UNITED STATES  
DEPARTMENT OF THE INTERIOR  
BUREAU OF LAND MANAGEMENTFORM APPROVED  
OMB NO. 1004-0135  
Expires: July 31, 2010**SUNDRY NOTICES AND REPORTS ON WELLS**  
*Do not use this form for proposals to drill or to re-enter an abandoned well. Use form 3160-3 (APD) for such proposals.*5. Lease Serial No.  
NMLC064391B

☒ Oil Well ☐ Gas Well ☐ Other8. Well Name and No.  
INDIAN HILLS UNIT GAS COM 272. Name of Operator  
OXY USA INC.Contact: DAVID STEWART  
E-Mail: david\_stewart@oxy.com9. API Well No.  
30-015-314063a. Address  
P.O. BOX 50250  
MIDLAND, TX 797103b. Phone No. (include area code)  
Ph: 432-685-5717  
Fx: 432-685-574210. Field and Pool, or Exploratory  
INDIAN BASIN UP. PENN

**Permanent Abandonment of Federal Wells**  
**Conditions of Approval**

OXY USA WTP LP - Proposed  
 Indian Hills Unit Gas Com. #27  
 API No. 30-015-31406

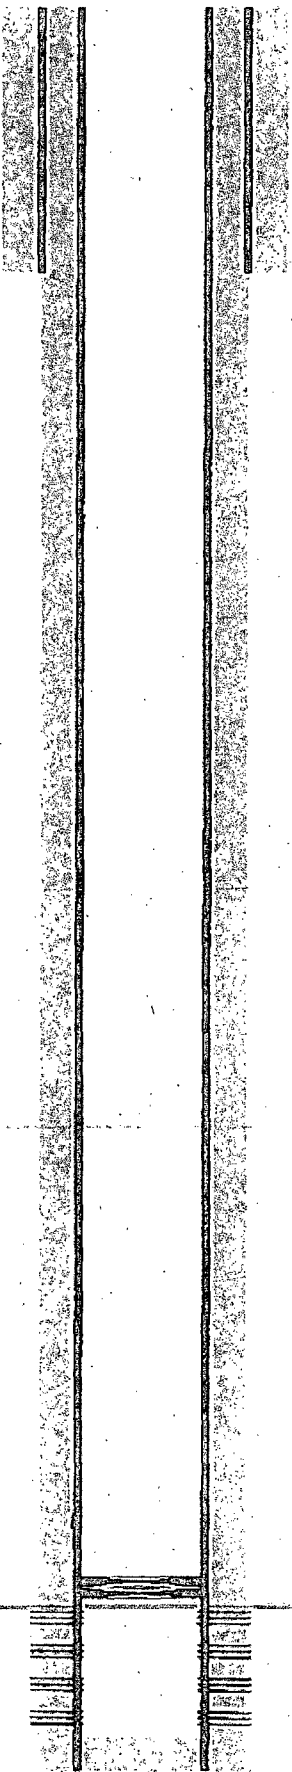
*Add plug: 130' from 3165-3035 (ECP @ 3100)  
WOC Tag.**Accepted for record  
WDS NMLC 11/5/14*RECLAMATION PROCEDURE  
ATTACHED
